SERVICE BULLETIN No 30-10

PRODUCTION CHANGE

**SUBJECT: GEAR SHIFT ROCKER ARM SUPPORT
VEHICLES: EIGHT - CYLINDER VEHICLES**

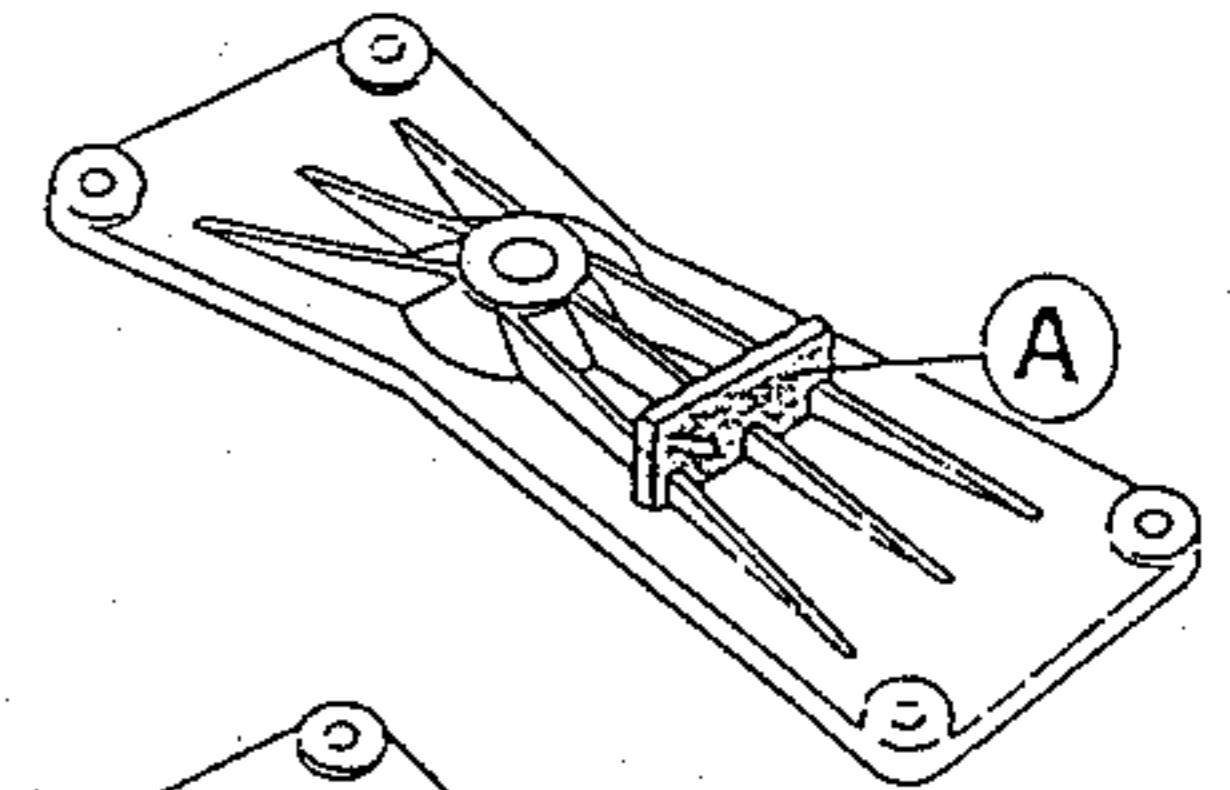
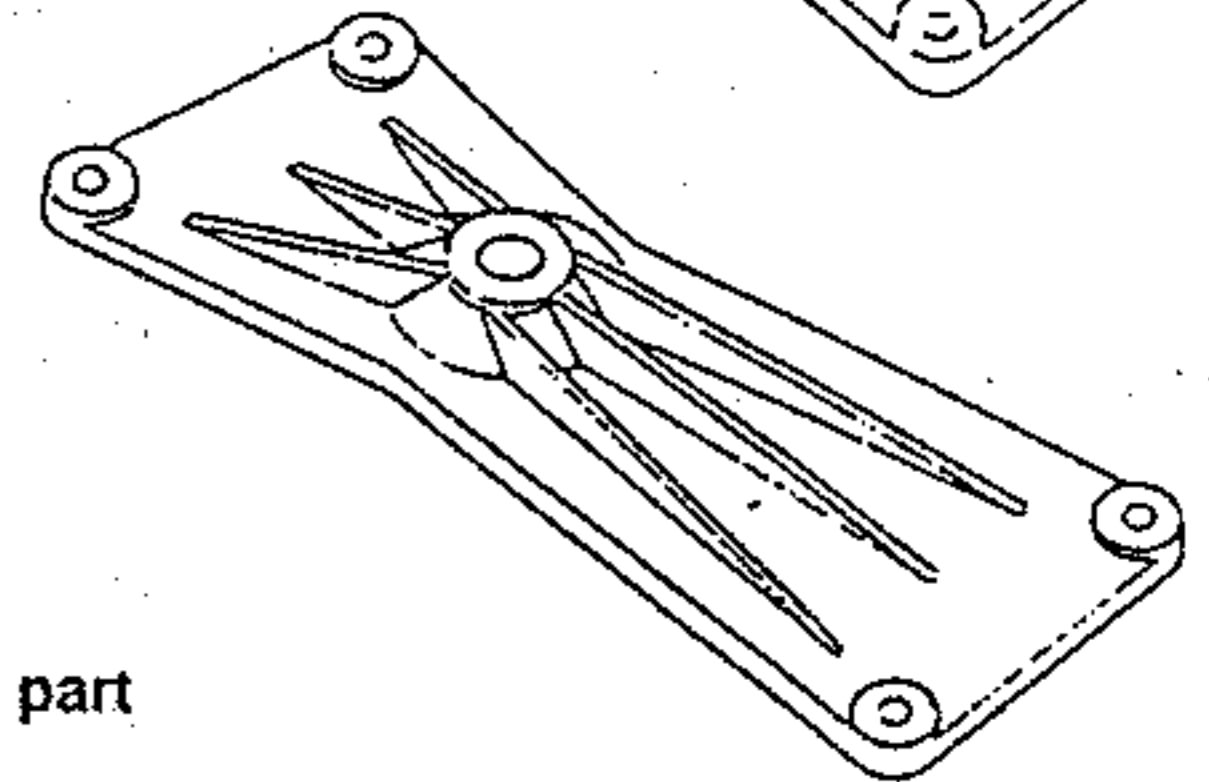
The gear shift rocker arm support (P.N. 114864) has been modified with the addition of a shoulder (A) as shown.

To avoid the disengagement of the gearshift fork (first and reverse gear) during servicing of gearbox.

Spare parts procedures: The modified support retains the same part number as the previous support ie. P.N.114864
